Management of Change: BASF process column K 2750 (DEXPI C02, unseen)

DRAFT - NOT APPROVED. Prepared 2026-11-02 16:01 +03 by PlantAgent from the working model. Nothing in this file is an approval.

5.2 P&ID Rev B - proposed (DRAFT - NOT APPROVED)

4.1 Replace column with 600 mm ID rated shell (vendor to confirm)

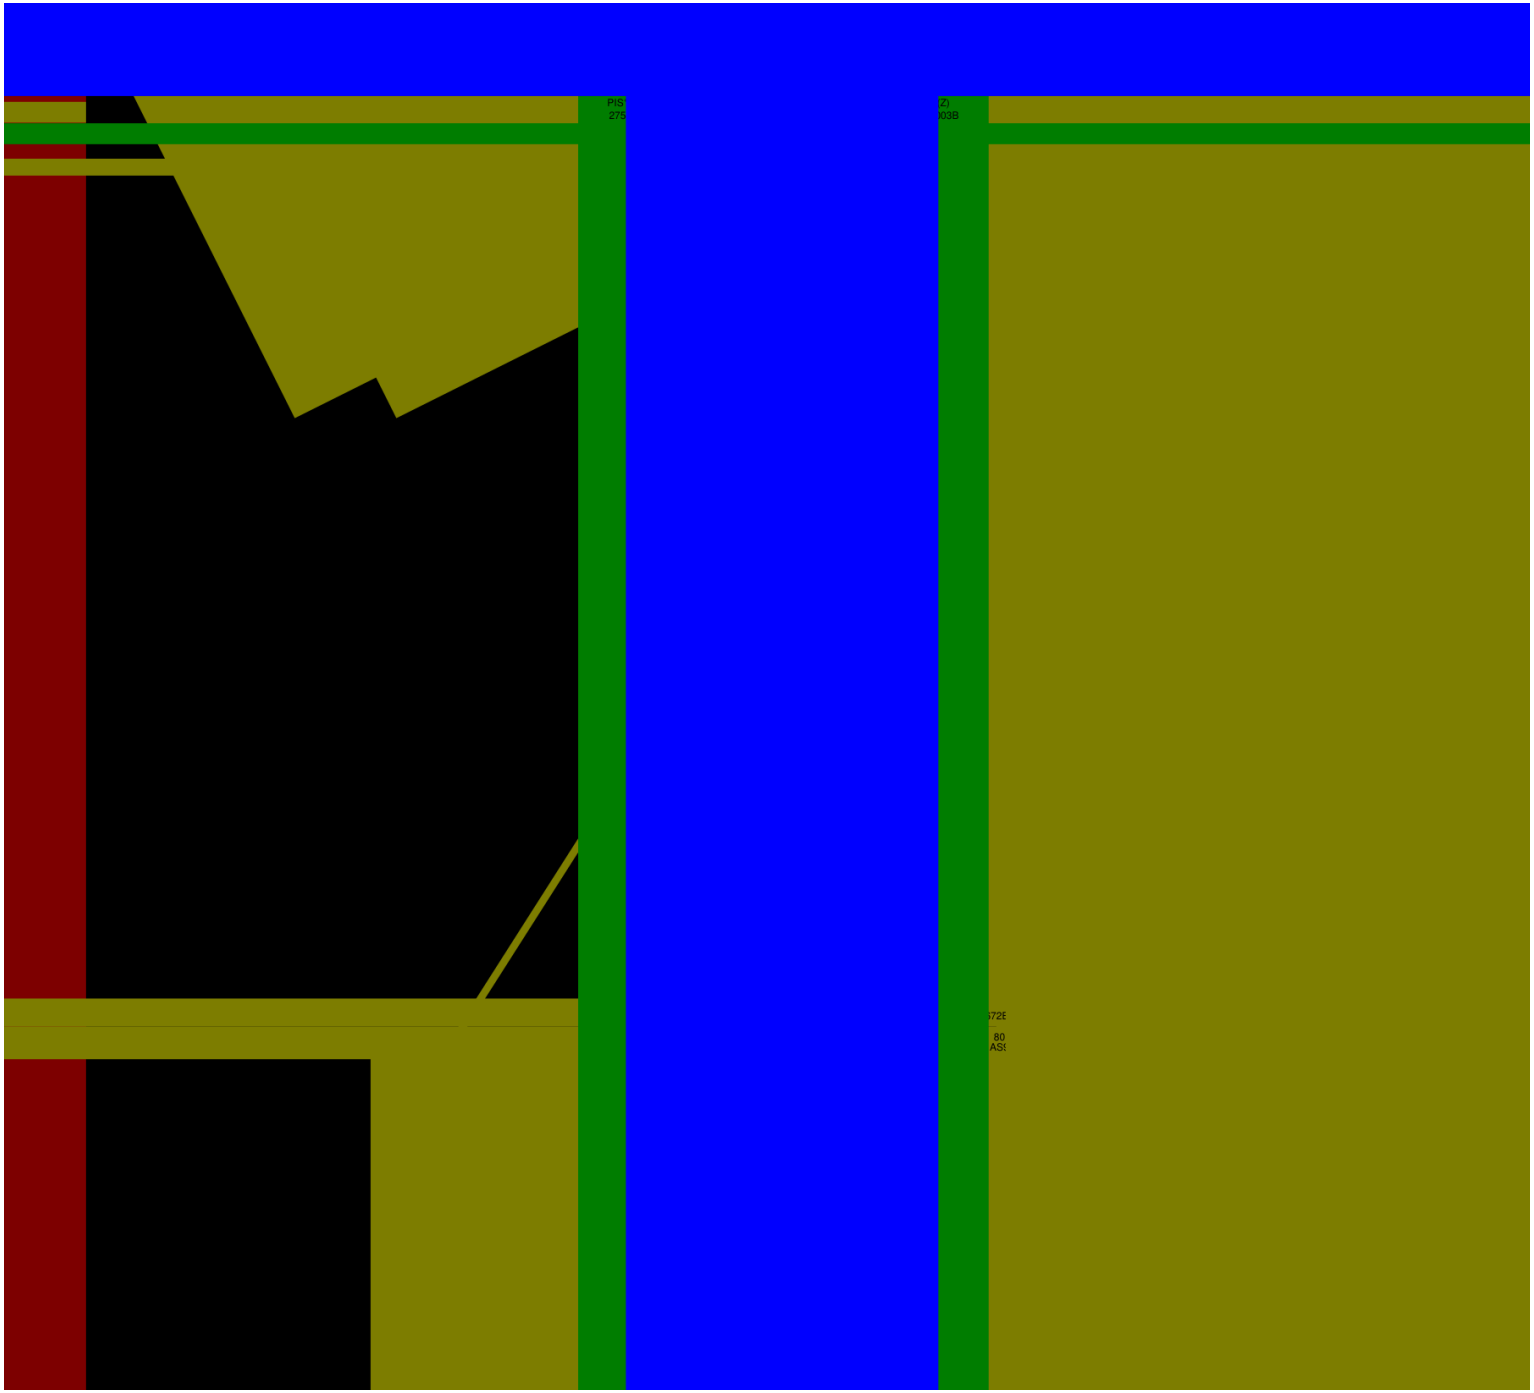
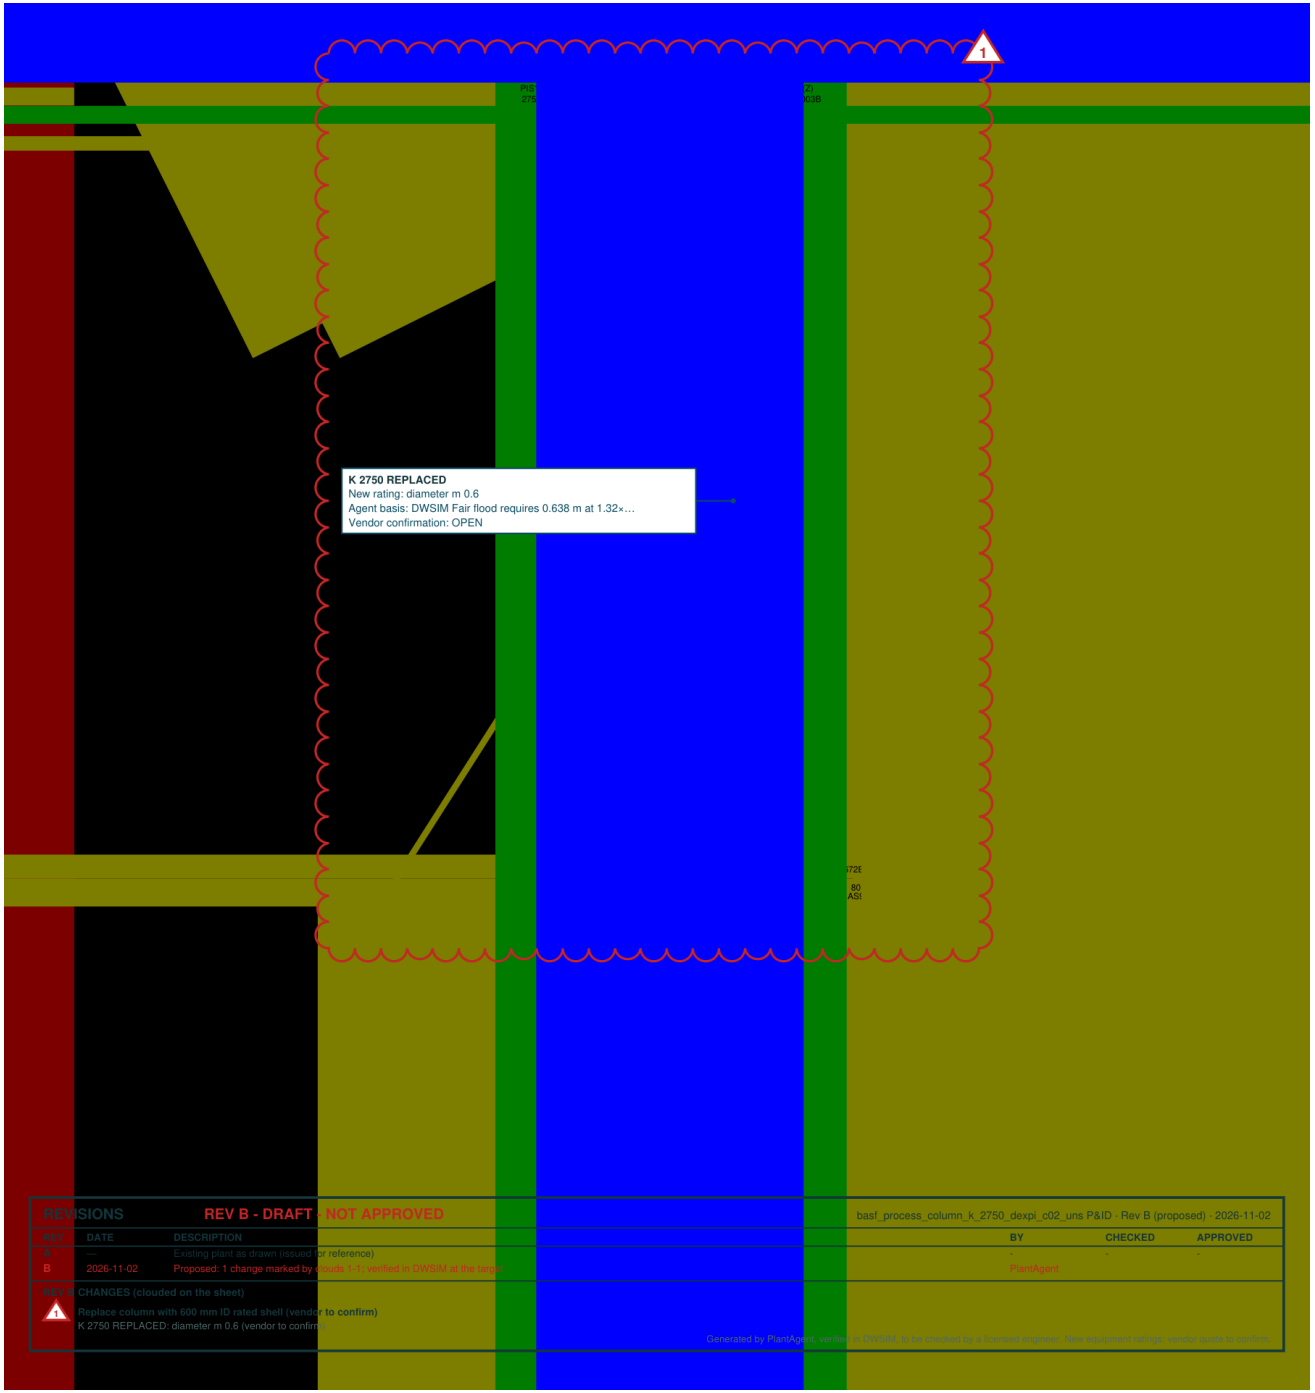
Cloud 1 on the Rev B drawing. Cost class (agent estimate, unpriced): not stated.

- Replaces K 2750 distillation: diameter m 0.6 (DWSIM Fair flood requires 0.638 m at 1.32× scaled 3.96 mol/s; 600 mm uniform (next standard matching KX 2750 600 mm section) gives 0.604 vs 0.80 =75.5 % at envelope (K2750_1p32_600_verify) and 0.549 =68.6 % at 1.2× (K2750_1p2_600 family); 525 mm gives 0.789 =98.6 % no margin (K2750_1p32_525). Height 14000 mm, 6 bar/150 °C, 1.4571, 15 stages same.; vendor to confirm)
- On the drawing: K 2750 REPLACED: diameter m 0.6 (vendor to confirm).

Why. Existing 500 mm ID cannot pass the +10 % operating envelope even with correct split: 0.869 vs 0.80 =108.6 % at 1.32× scaled (K2750_1p32_scaled_500) and 1.008 =126 % fixed (K2750_1p32_fixed_500). All documented P/T checks pass (<61 % at 1.32×) so flooding and purity are the only documented limits. New 600 mm ID provides required capacity with margin; vendor to confirm tray/valve design, downcomers, nozzles for line 2750.001.6 and *at N3*/*C2* valve.

- K 2750: agent-proposed sizing basis (not independently validated): DWSIM Fair flood requires 0.638 m at 1.32× scaled 3.96 mol/s; 600 mm uniform (next standard matching KX 2750 600 mm section) gives 0.604 vs 0.80 =75.5 % at envelope (K2750_1p32_600_verify) and 0.549 =68.6 % at 1.2× (K2750_1p2_600 family); 525 mm gives 0.789 =98.6 % no margin (K2750_1p32_525). Height 14000 mm, 6 bar/150 °C, 1.4571, 15 stages same.; vendor confirmation open
- Sizing basis cites trial runs with other changes; the server verified the replacement alone.
